UNITED STATES PATENT AND TRADEMARK OFFICE

Office Action Summary

10/708,692

DETAILED ACTION

FIG. 11

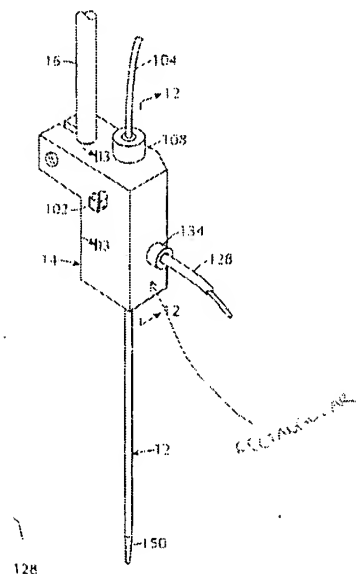
Kerr discloses as follows:

The Kerr reference provides all the structural elements of the claimed limitations; therefore, Kerr is capable of function as an apparatus for attaching a proximity probe offset to an axis defining a metal probe case and an extension cable extending therefrom.

Kerr fails to disclose the case to be made with metal.

At the time the invention was made, it would have been an obvious matter of design choice to a person of ordinary skill in the art to make the case with metal because Applicant has not disclosed that making the case with metal provides an advantage, is used for a particular purpose, or solves a stated problem. One of ordinary skill in the art, furthermore, would have expected the case to be made with metal to provide strength and durability from continued use.
